Office of General Services

ADDENDUM NO. 2 TO PROJECT NO. 47676

CONSTRUCTION WORK FUEL TANK MODIFICATION & ENVIRONMENTAL REMEDIATION – WESTERN REGION SERVICE CONTRACT GNARESP CORNING TOWER ALBANY, NY 12242

May 27, 2025

MARK	DATE	DESCRIPTION
	5/22/2025	ADDENDUM NO. 2
	1/31/2025	FINAL SUBMISSION
PROJECT NUMBER:	47676 - C	
DESIGNED BY:	M. GUTMANN	
DRAWN BY:	A. KELLY	
FIELD CHECK:	M. WESOLOWSKI	
APPROVED:	M. WESOLOWSKI	
SHEET TITLE:	DUAL HOSE DISPENSER ISLAND FIRE SUPPRESSION DETAILS	
DRAWING NUMBER:	C-24

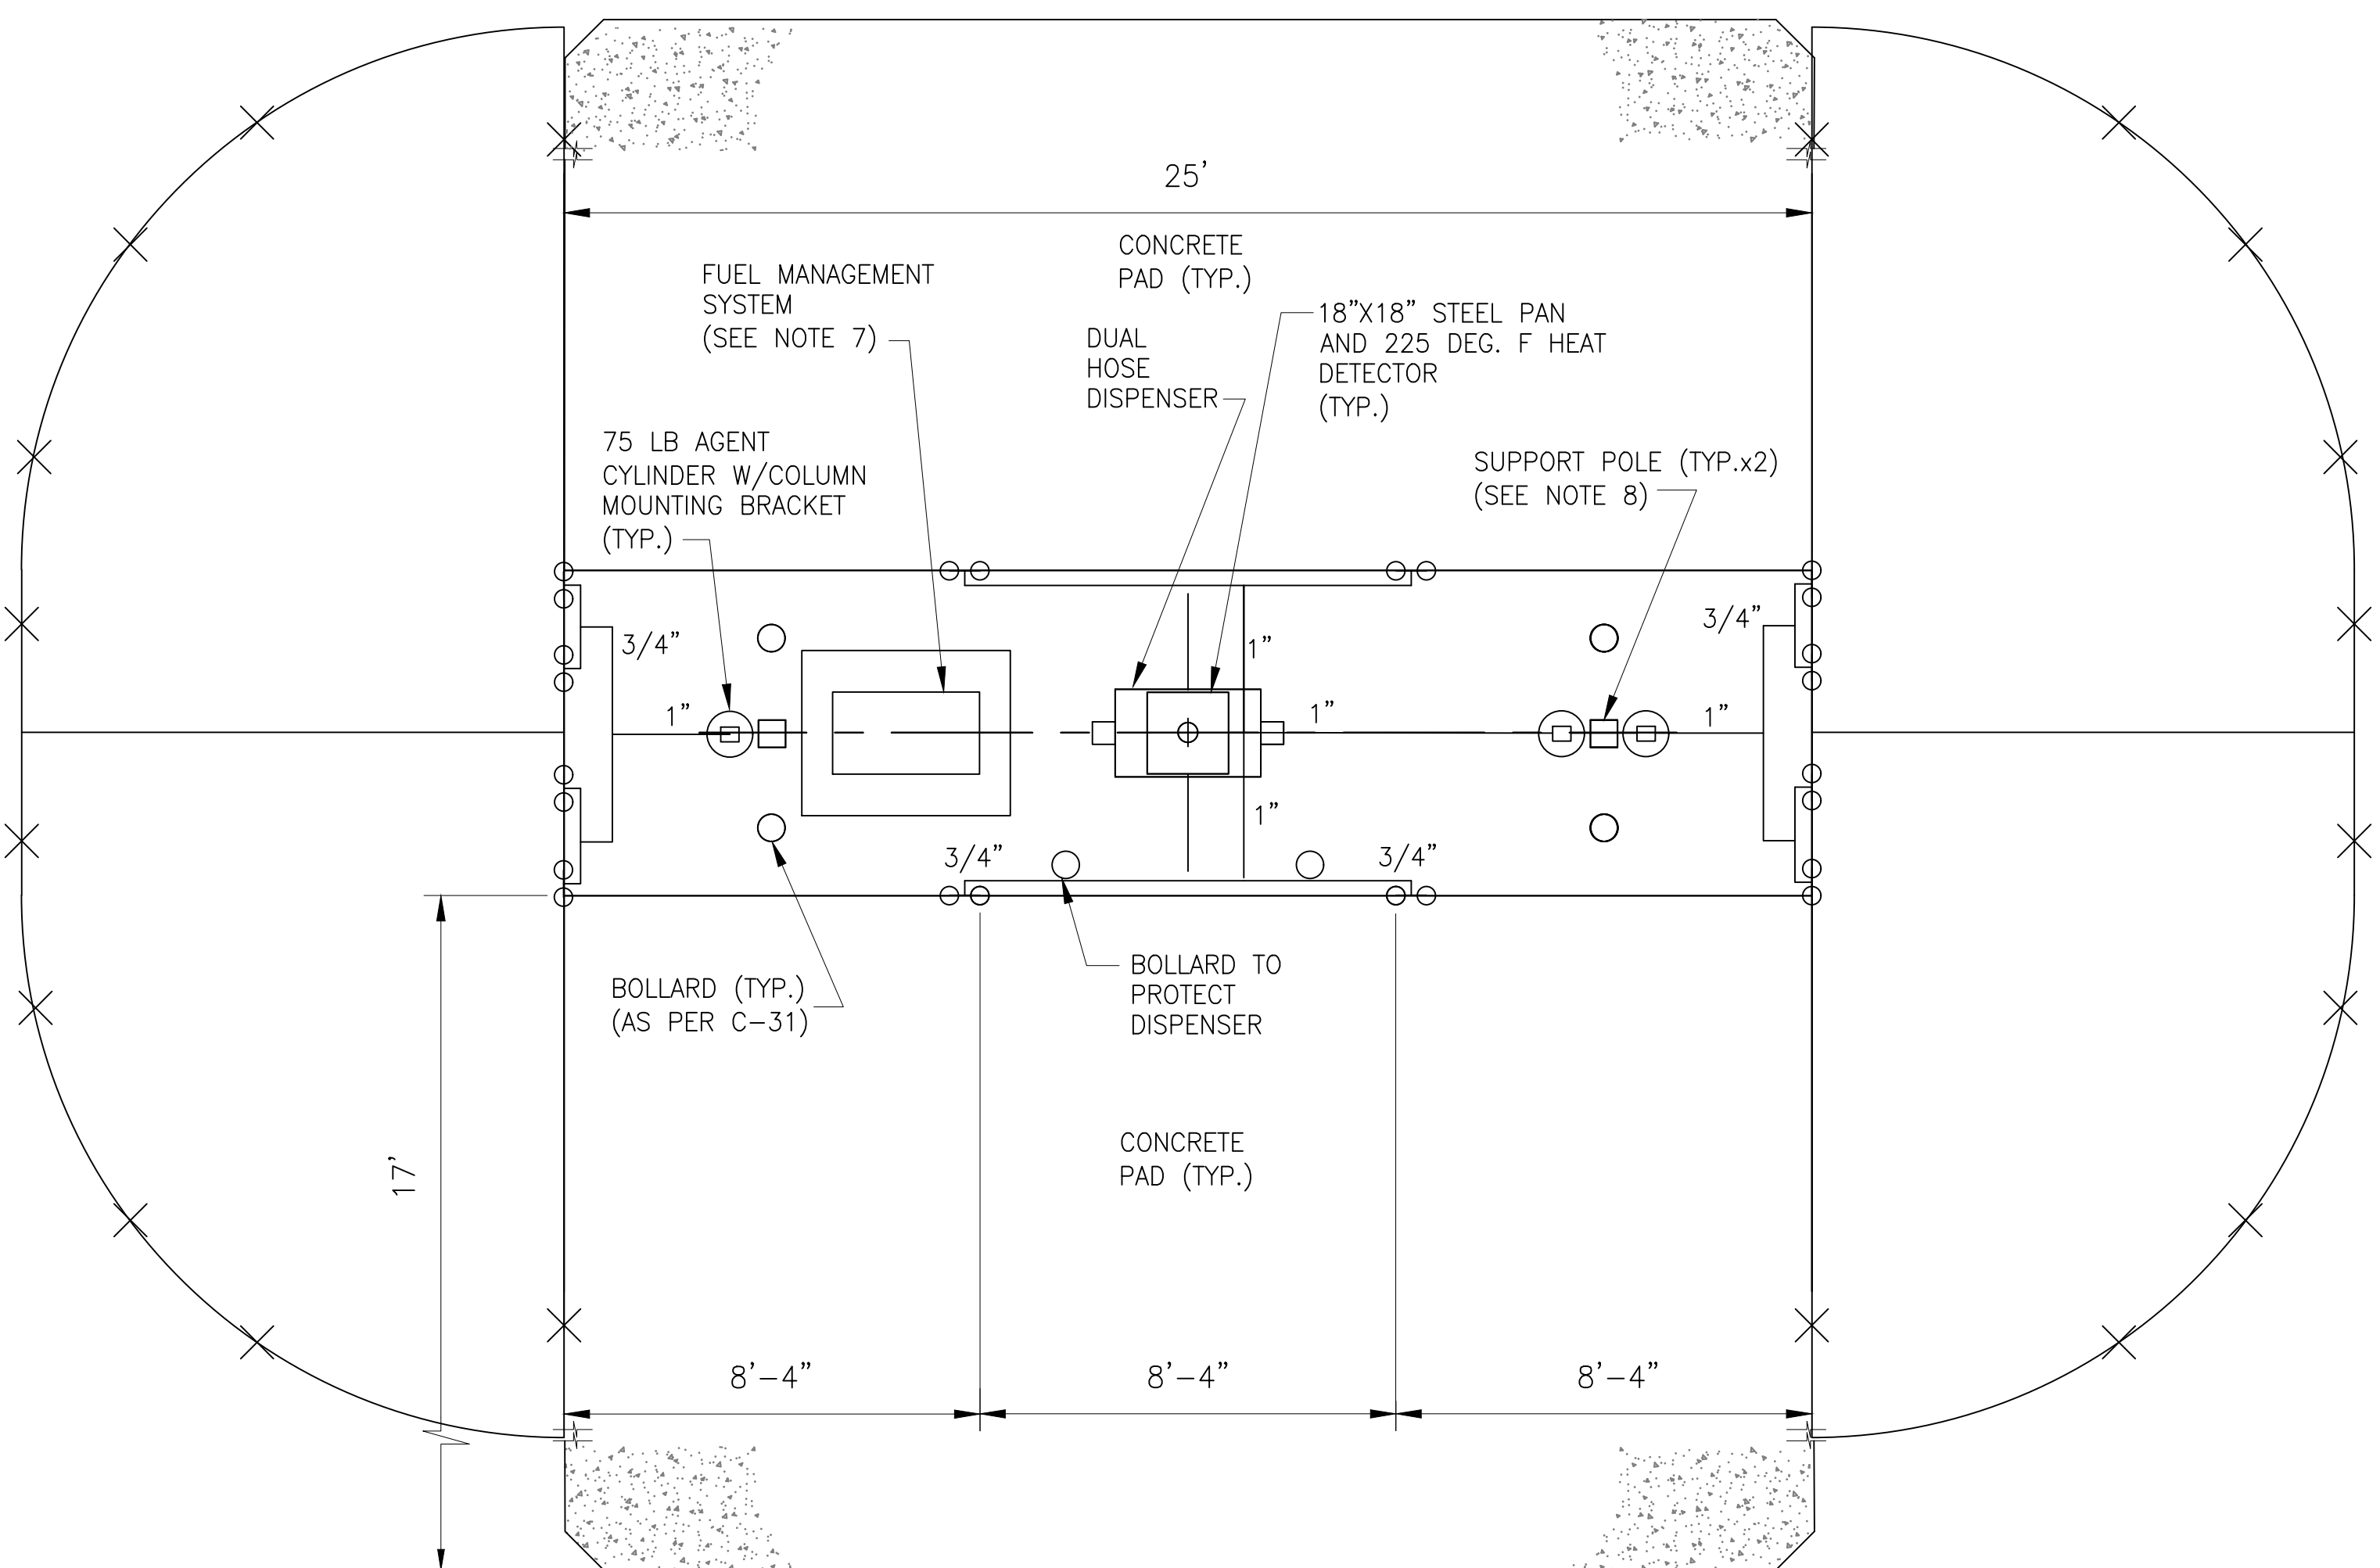
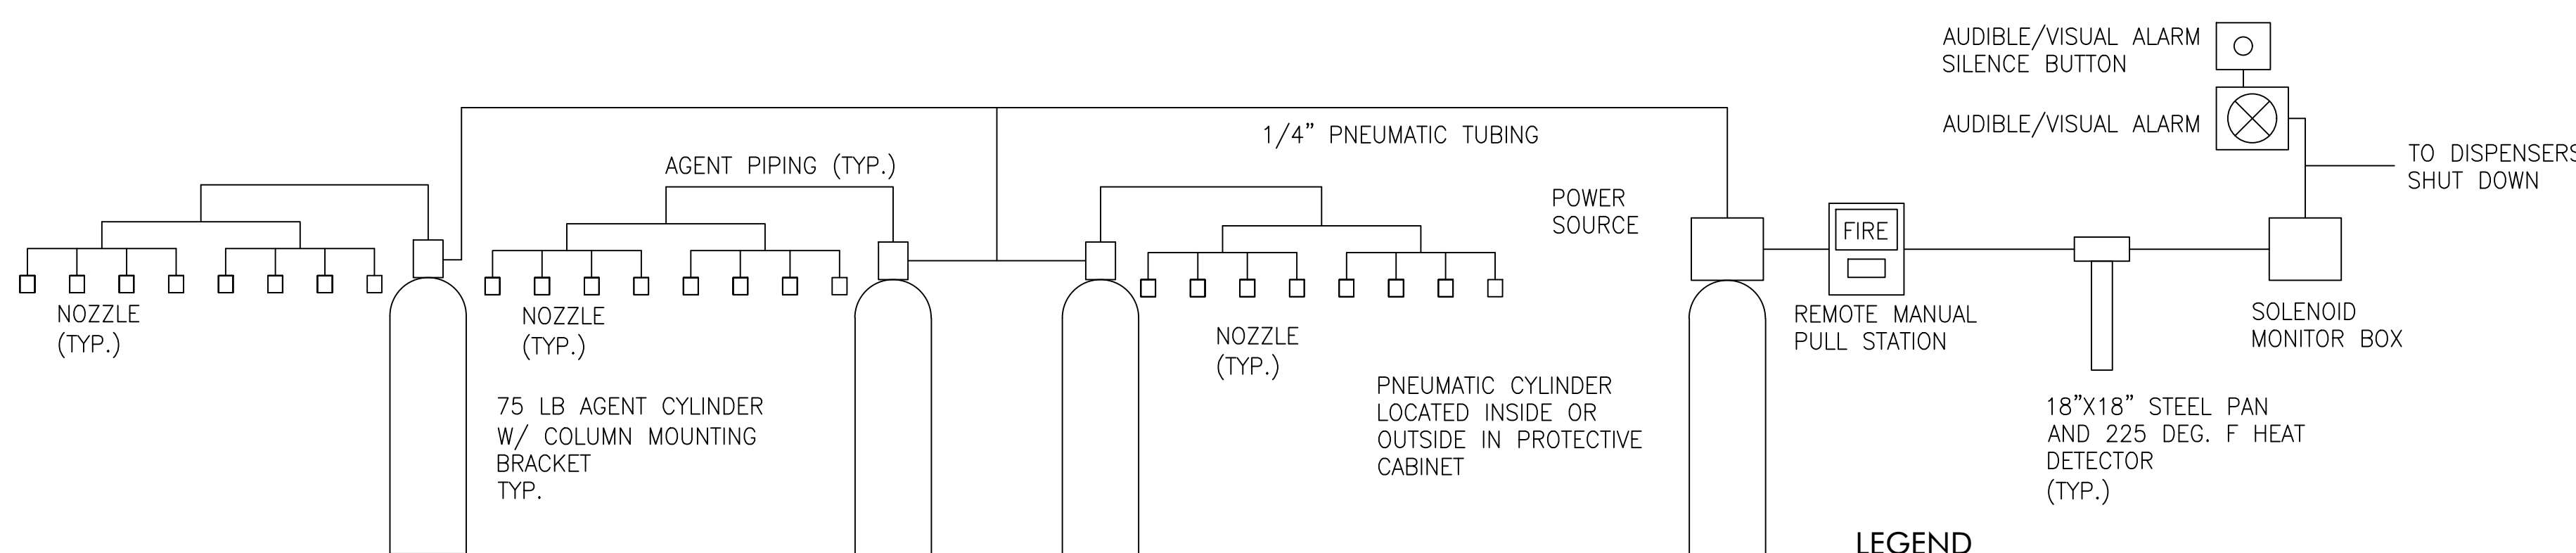
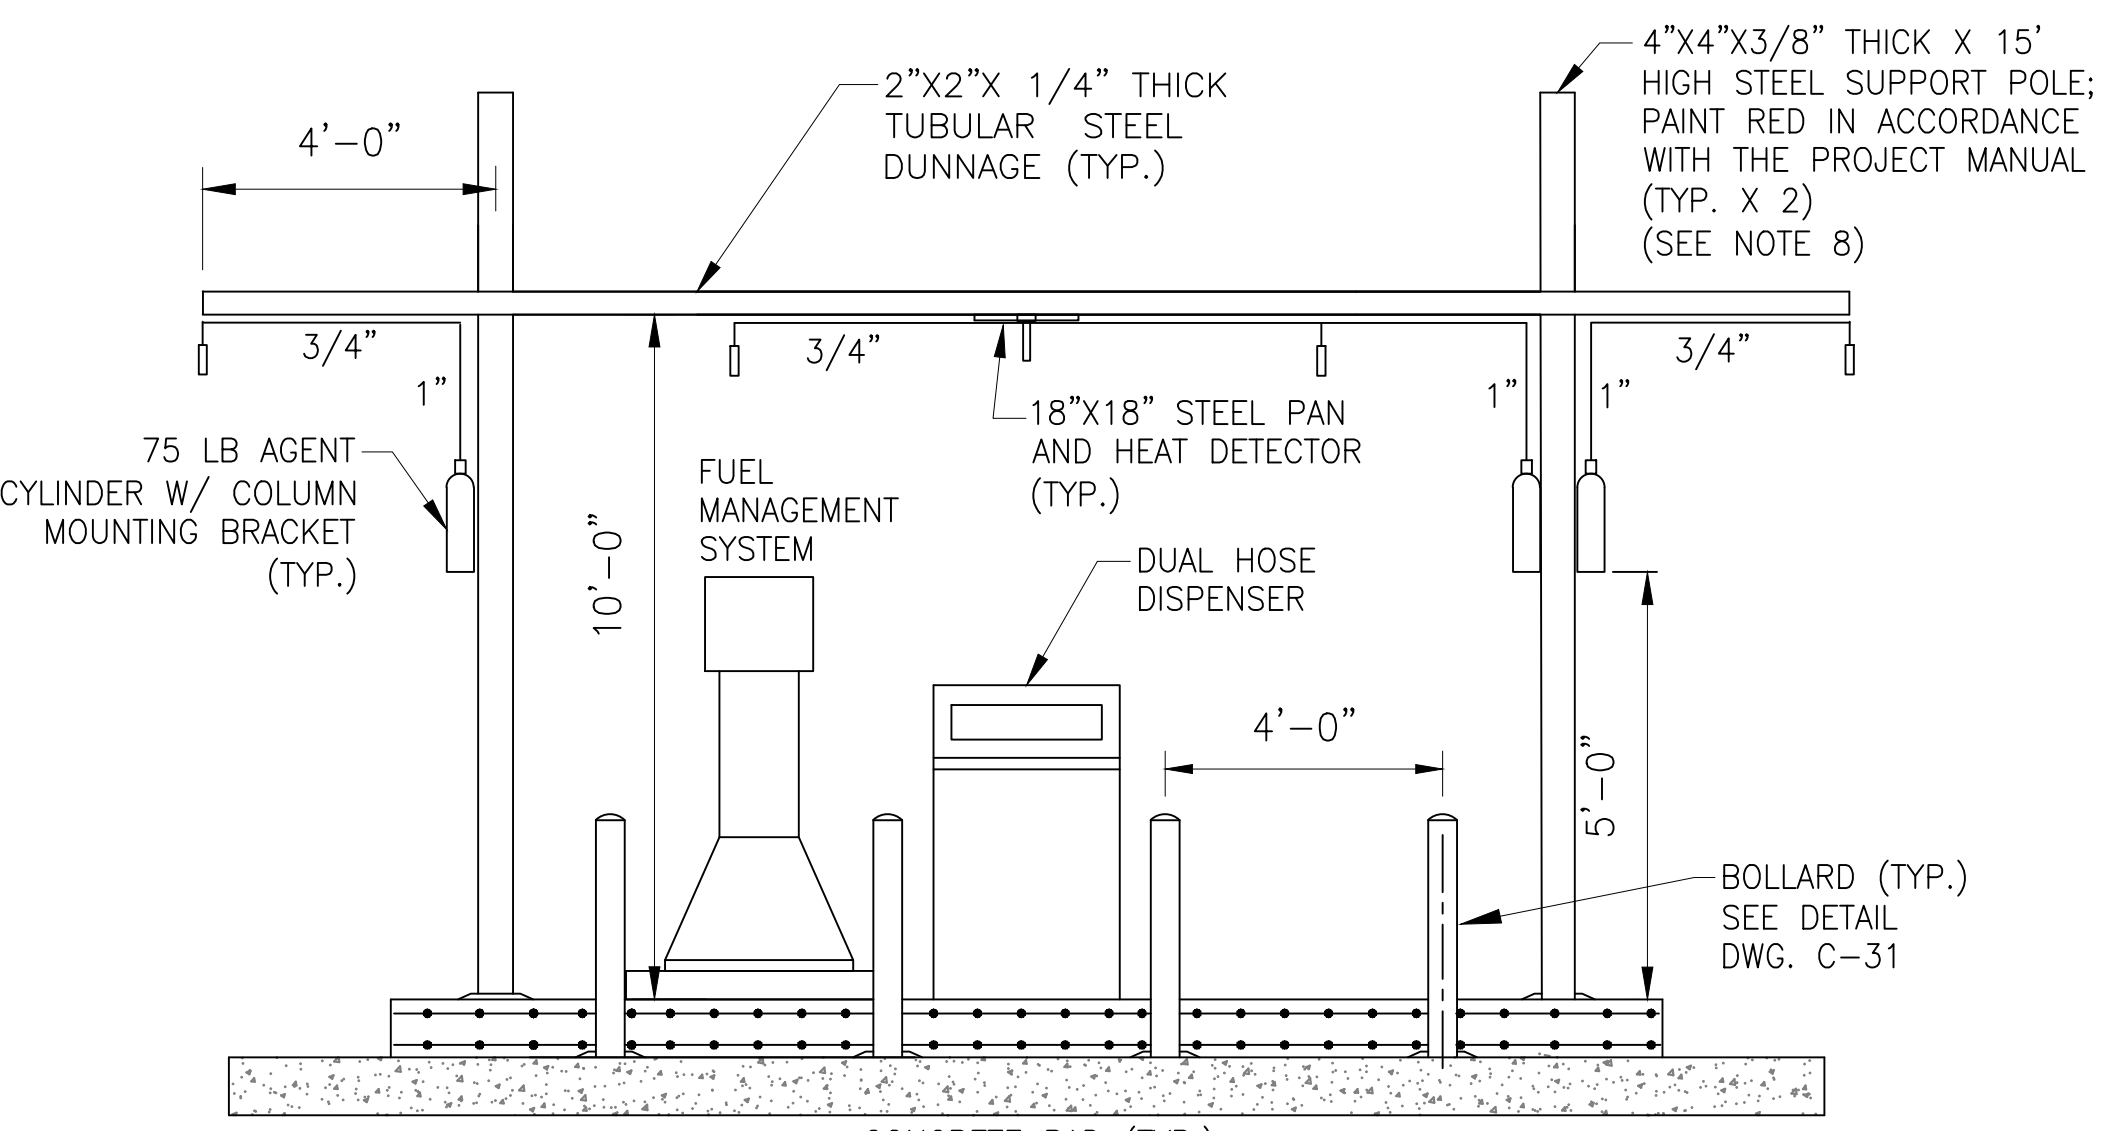
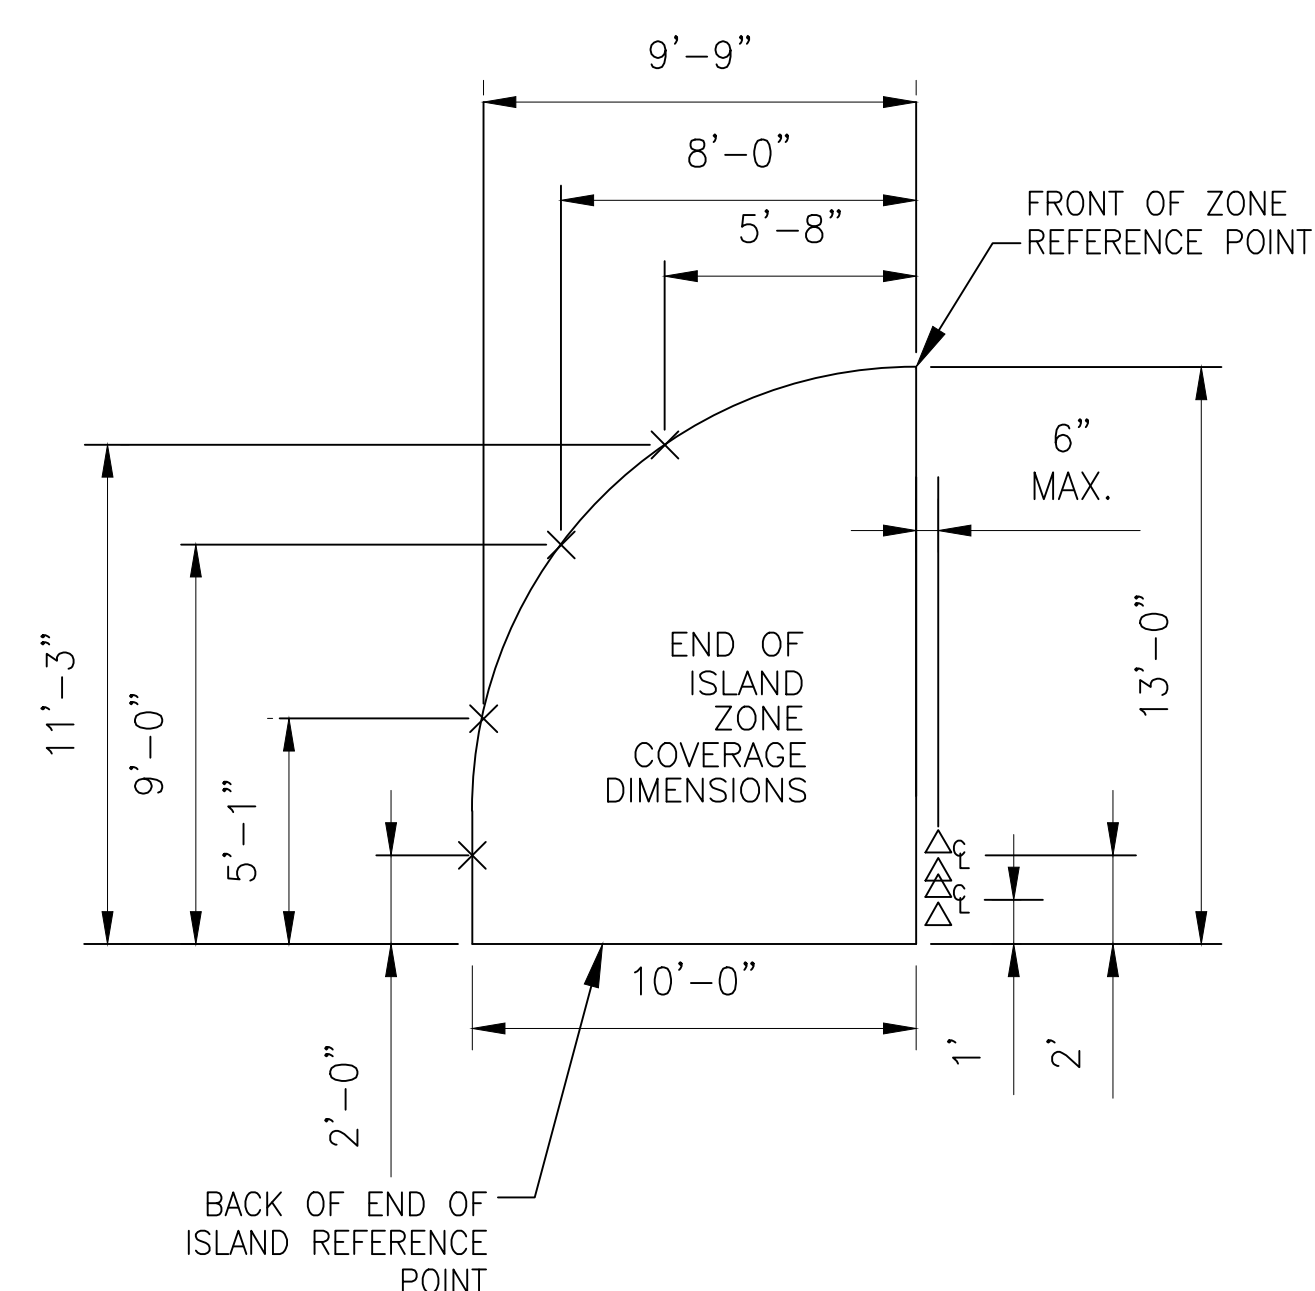
2. Revised Drawings:
 - a. Drawing Nos. C-23, C-24, and C-25, noted “ADDENDUM NO. 2 5/22/2025” accompany this Addendum and supersede the same numbered originally issued drawings.
